D.N.D.

SMALL HOUSE DESIGNS

PREPARED BY CENTRAL MORTGAGE & HOUSING CORPORATION

Preliminary Resume of D.N.D. House Designs

113/54/S

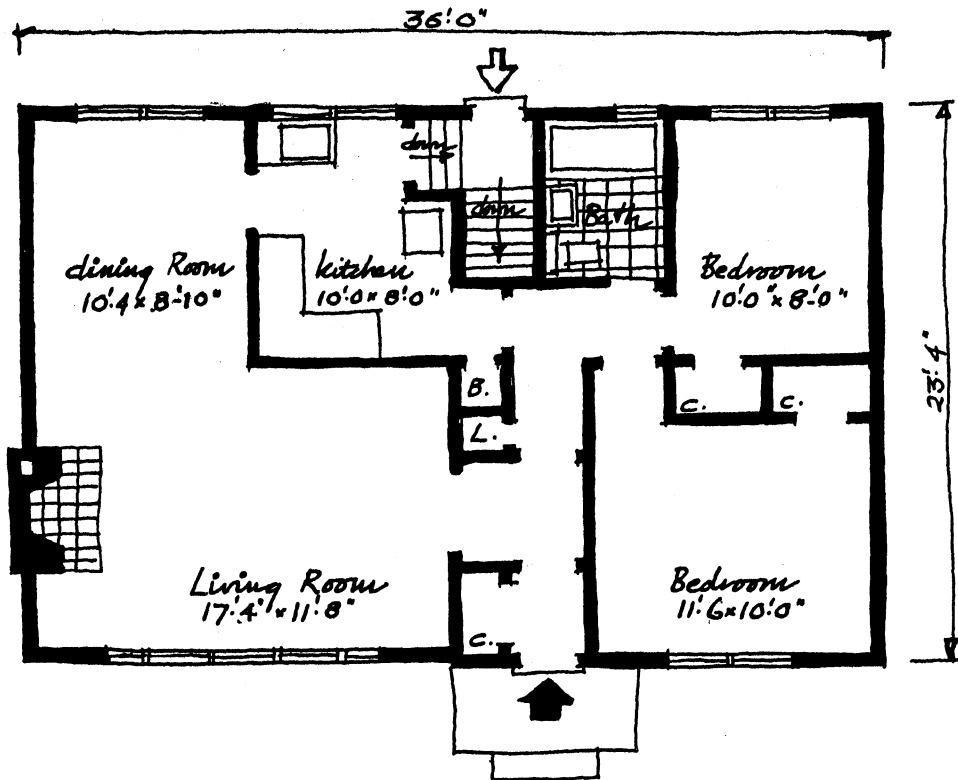
1. Remove wall between kitchen and dining room and replace with cabinets.
2. Remove fireplace.
3. D.N.D. accepts this house.

114/54/S

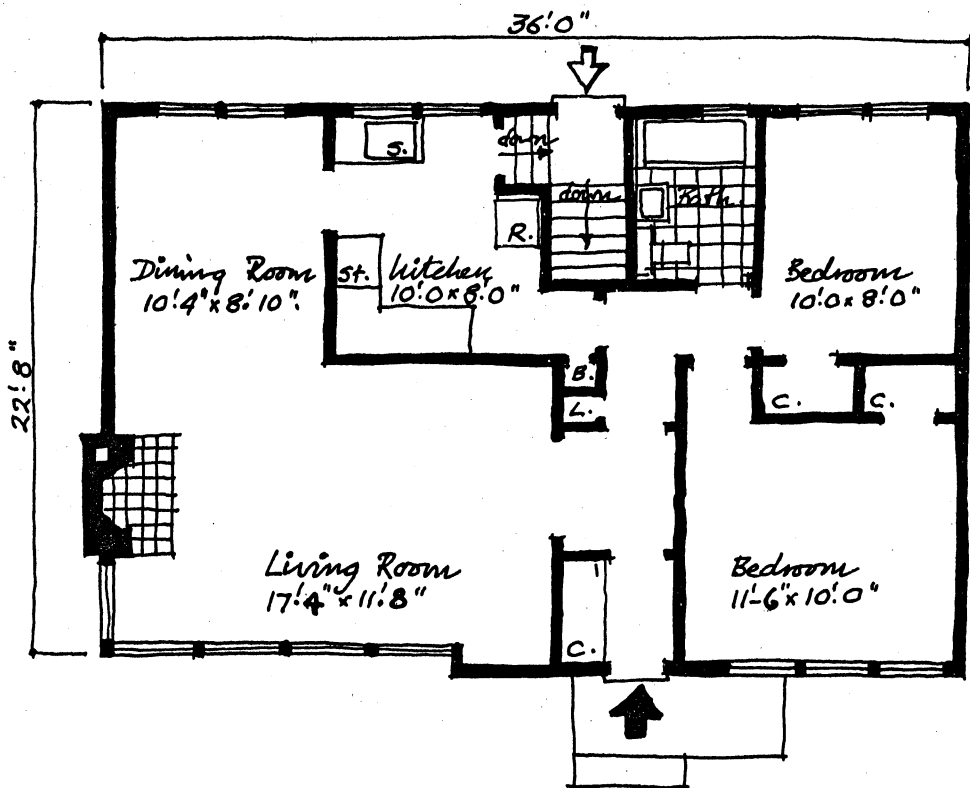
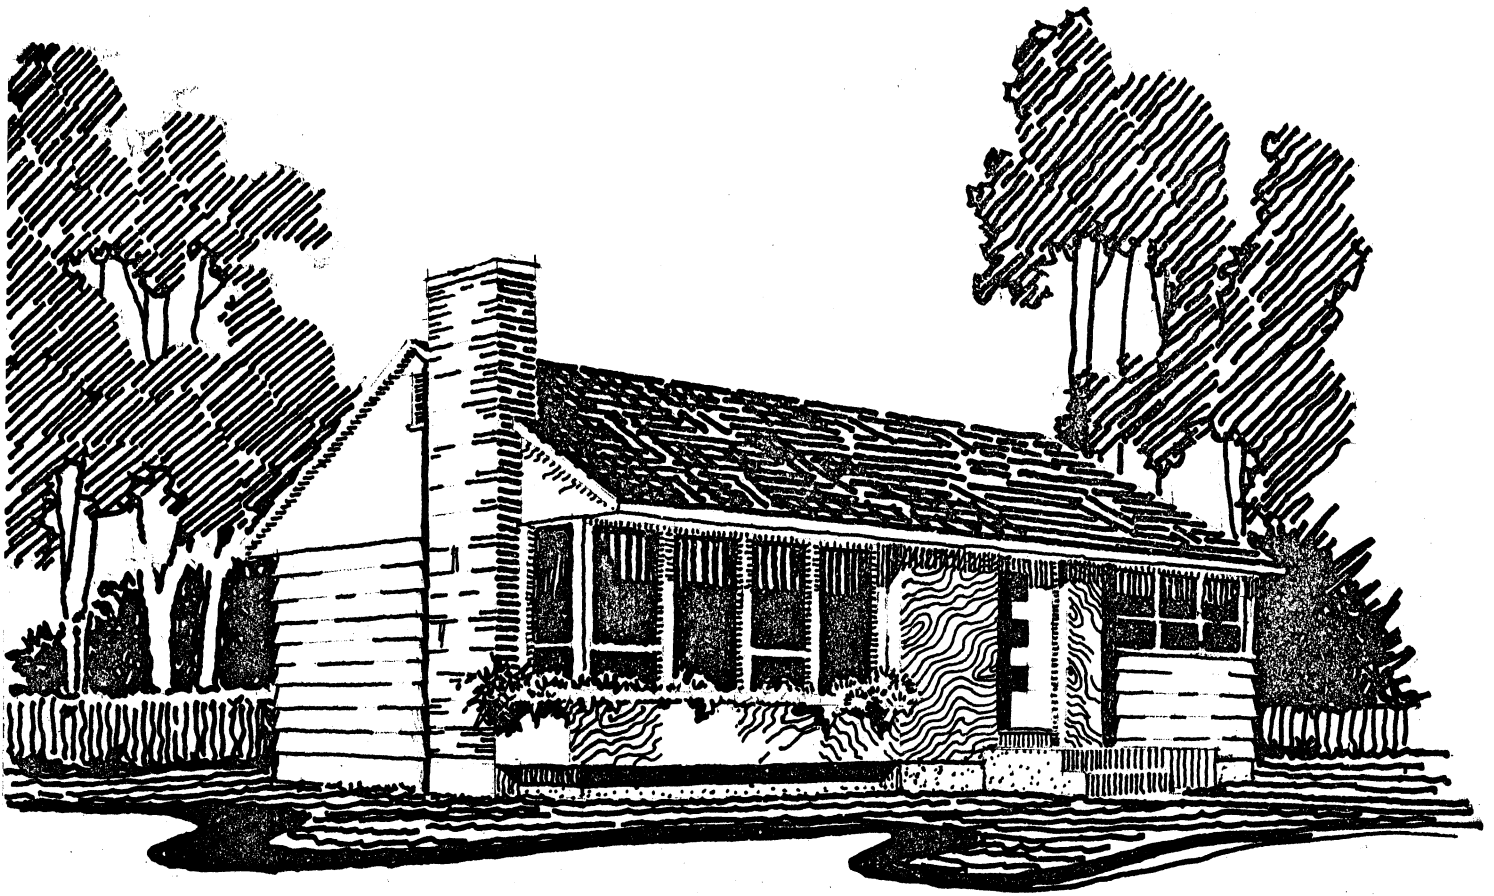
1. Remove wall between kitchen and dining room and replace with cabinets.
2. Remove fireplace.
3. D.N.D. accepts this house.

H/54/T

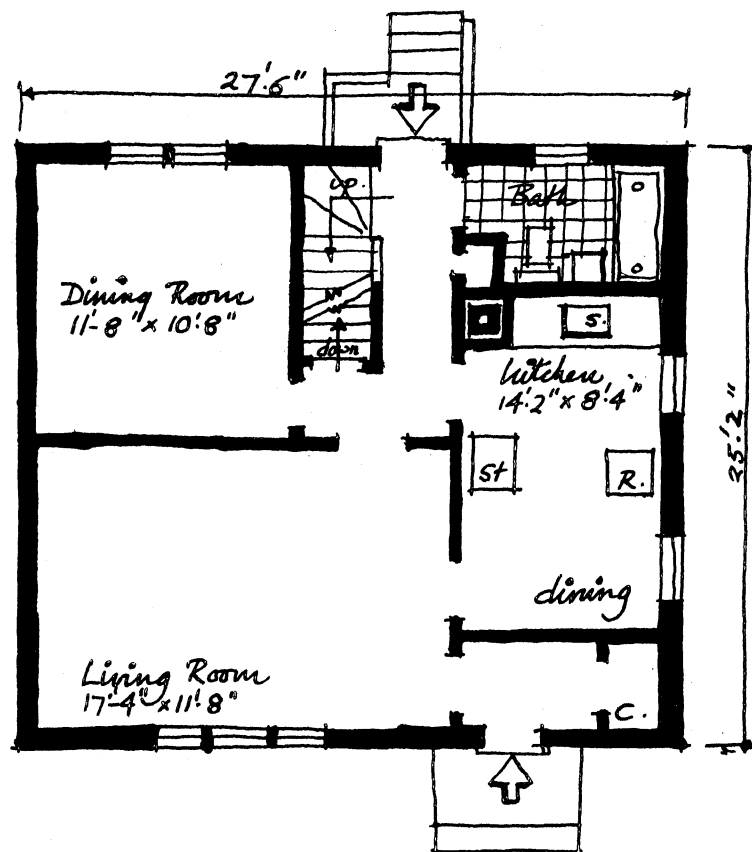
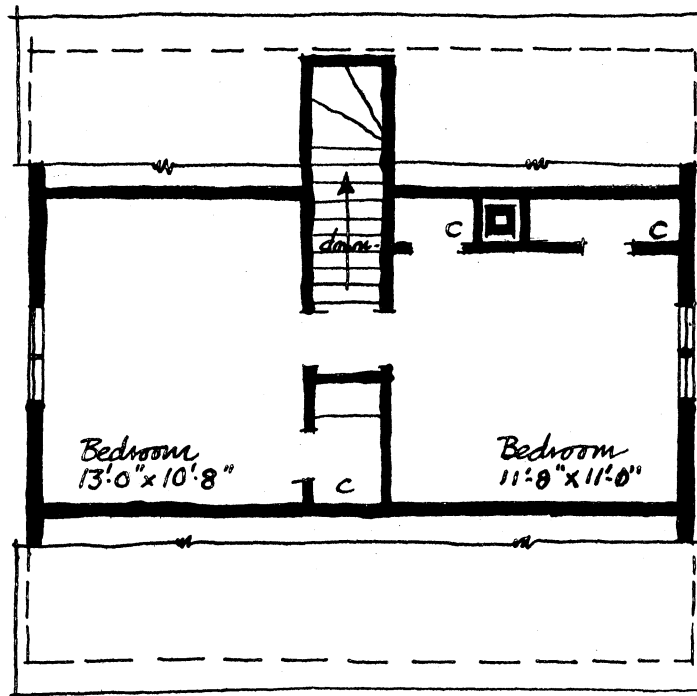
1. D.N.D. accepts this house.
2. Attempt to design cover over front entrance.

H/54/C

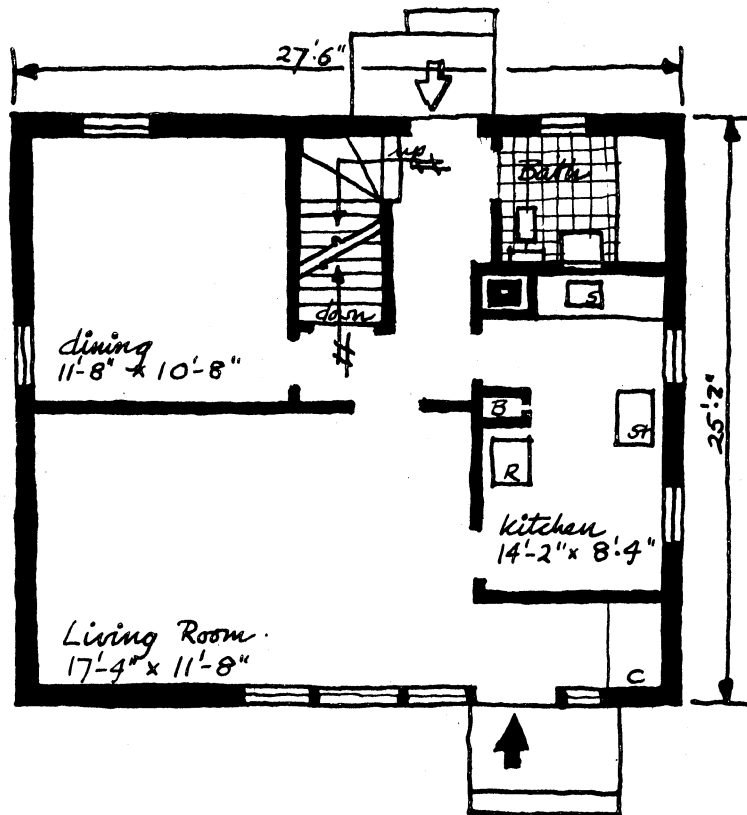
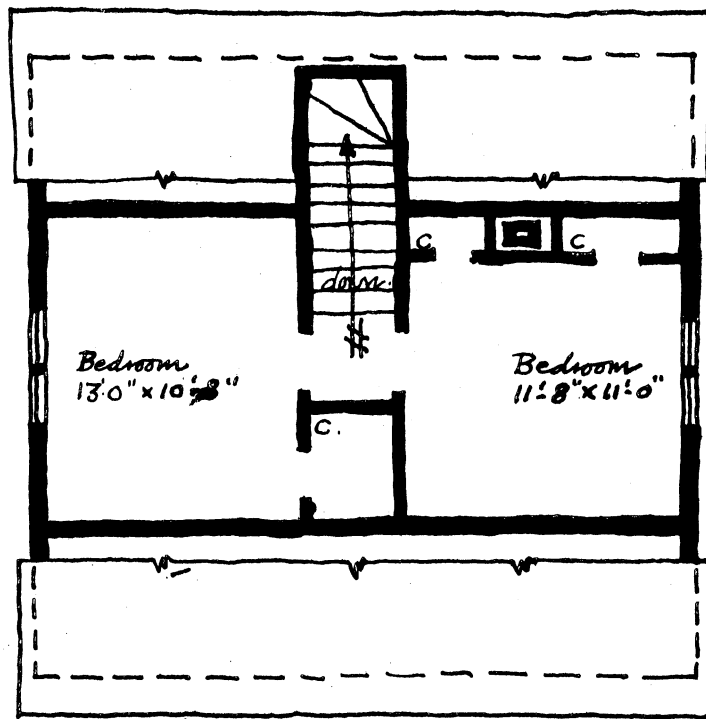
1. D.N.D. accepts this house with reservations to be used sparingly.

Y/54/T

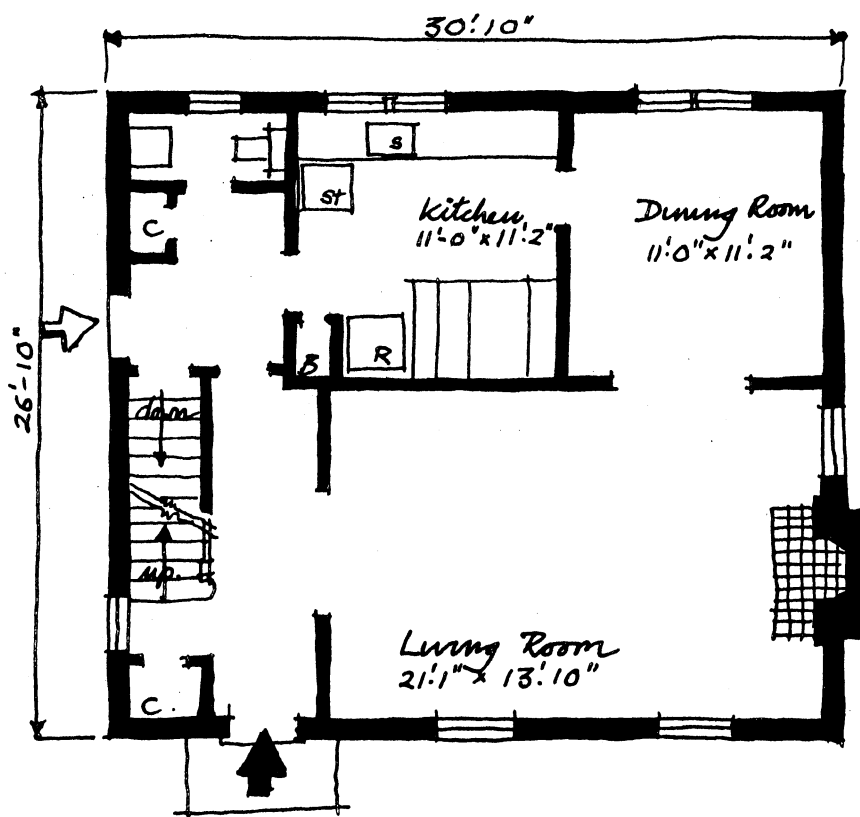
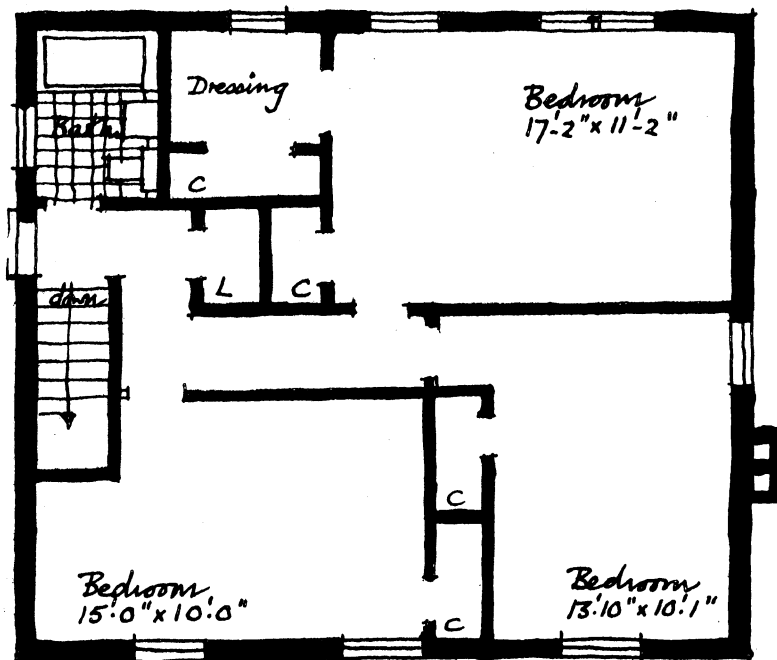
1. Suggest gutter on front.
2. D.N.D. accept this plan.

Y/54/S

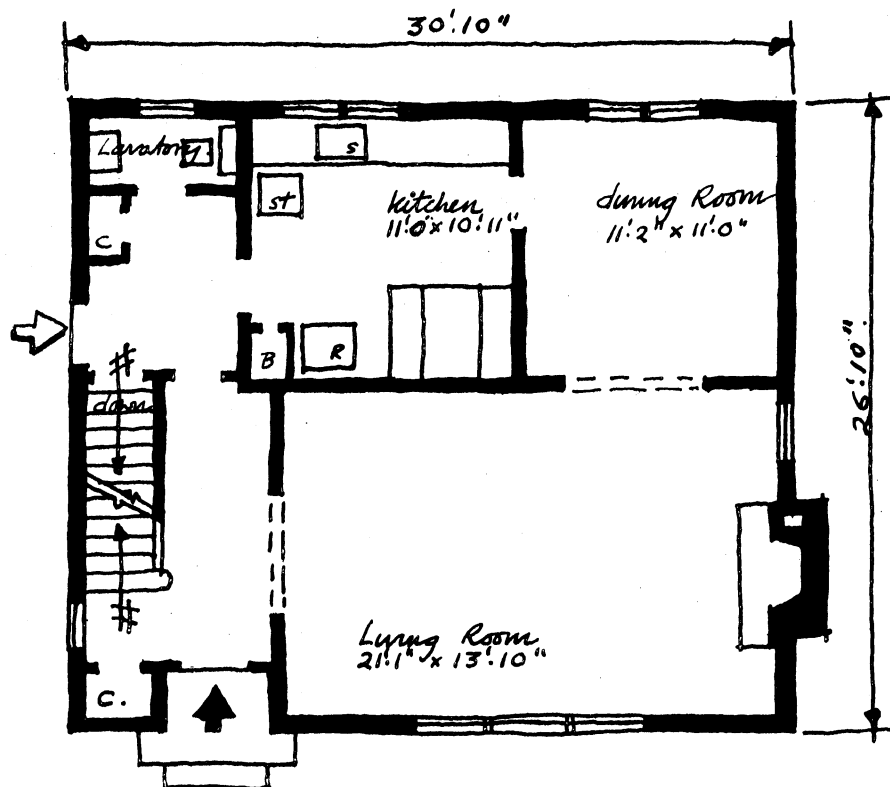
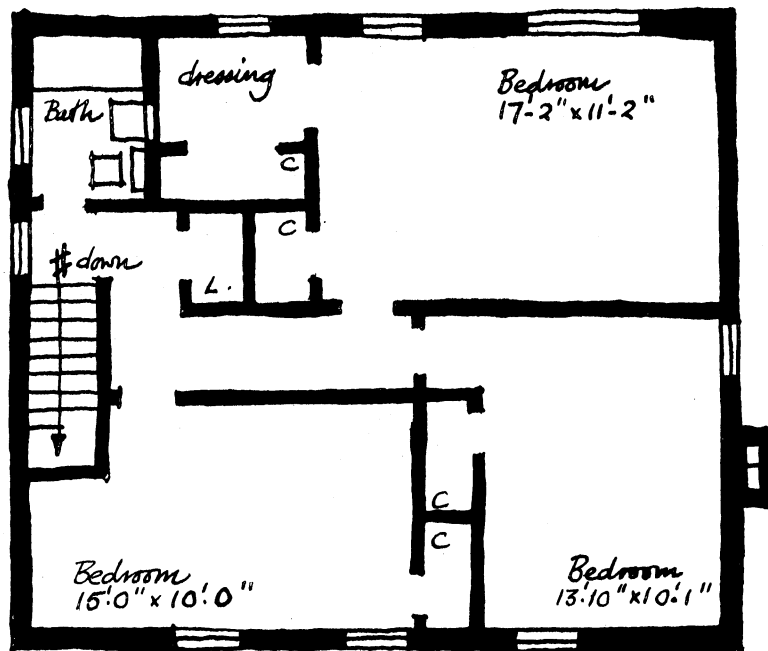
1. Same comments as for Y/54/T.

Y/54/C

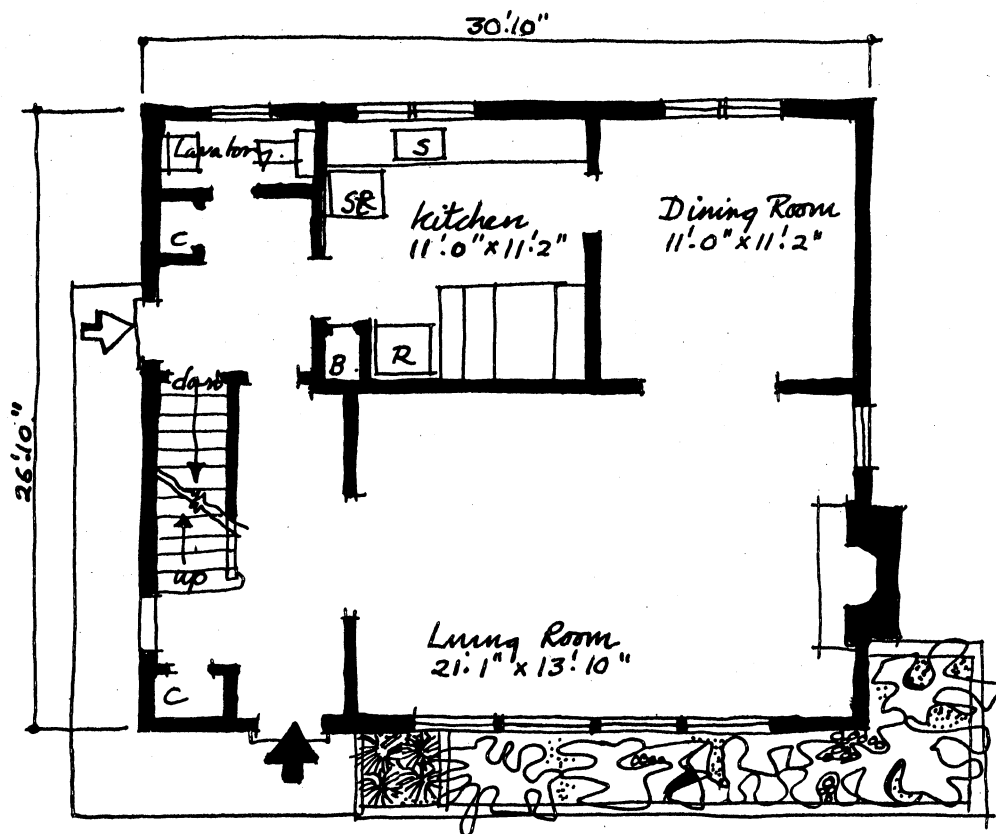
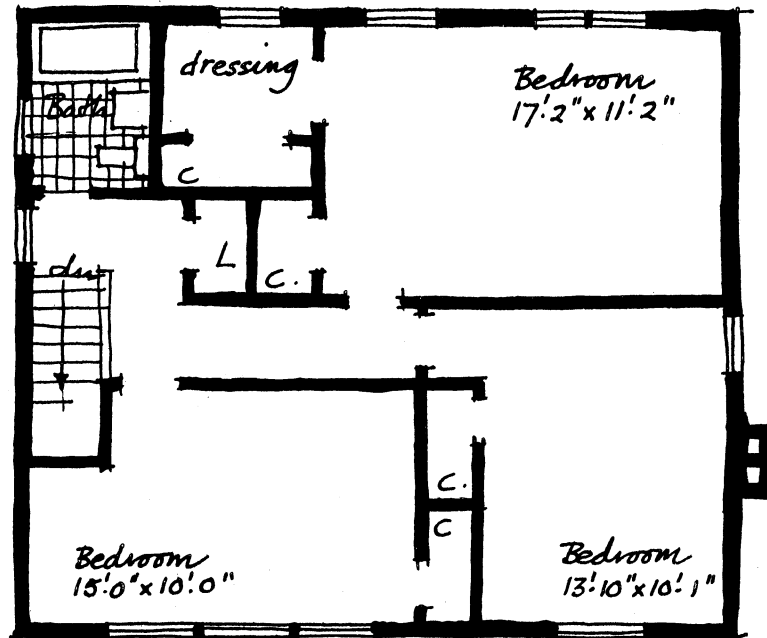
1. Same comments as for Y/54/T.

R/54/T

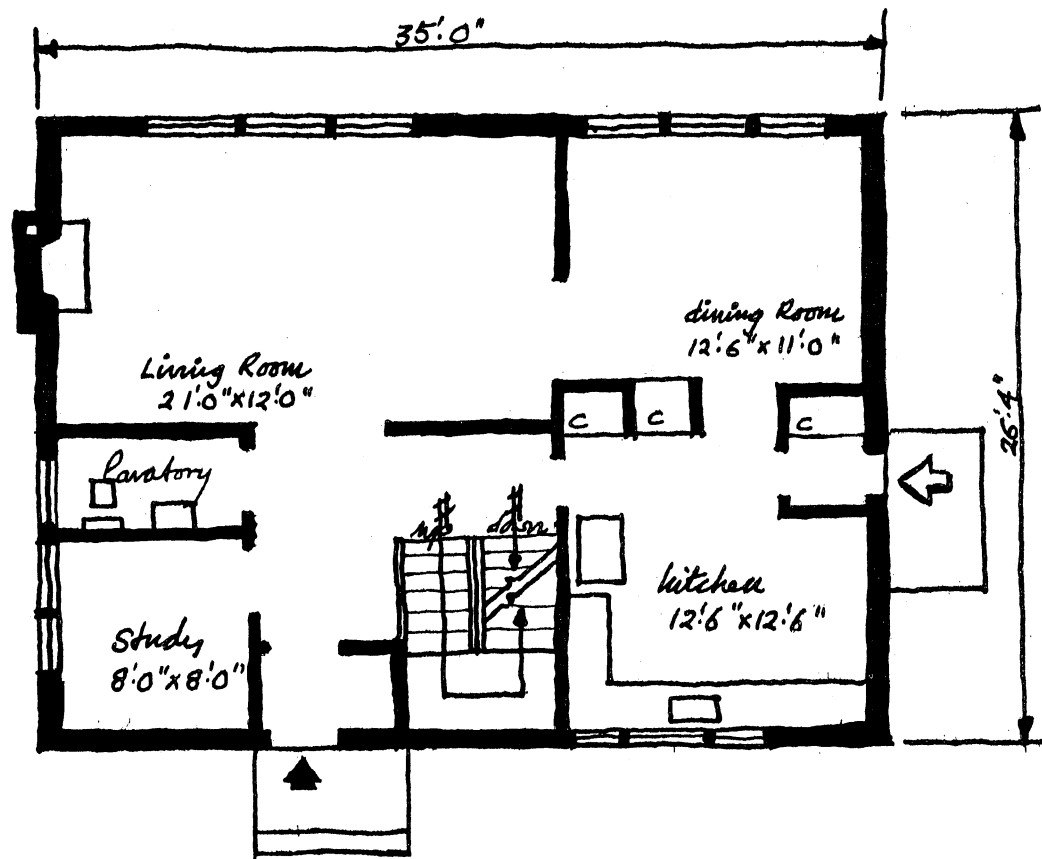
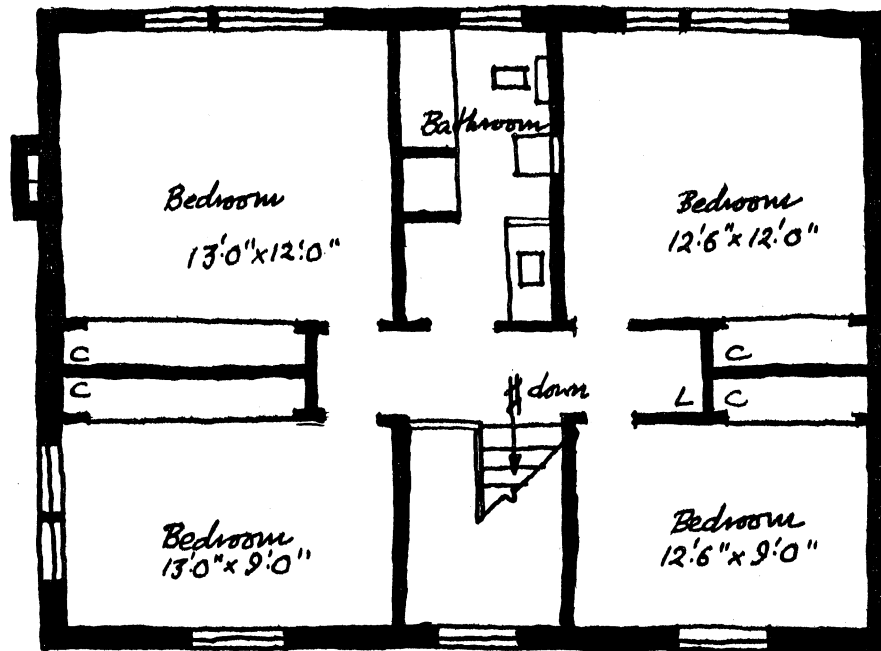
1. Further discussion with D.N.D.
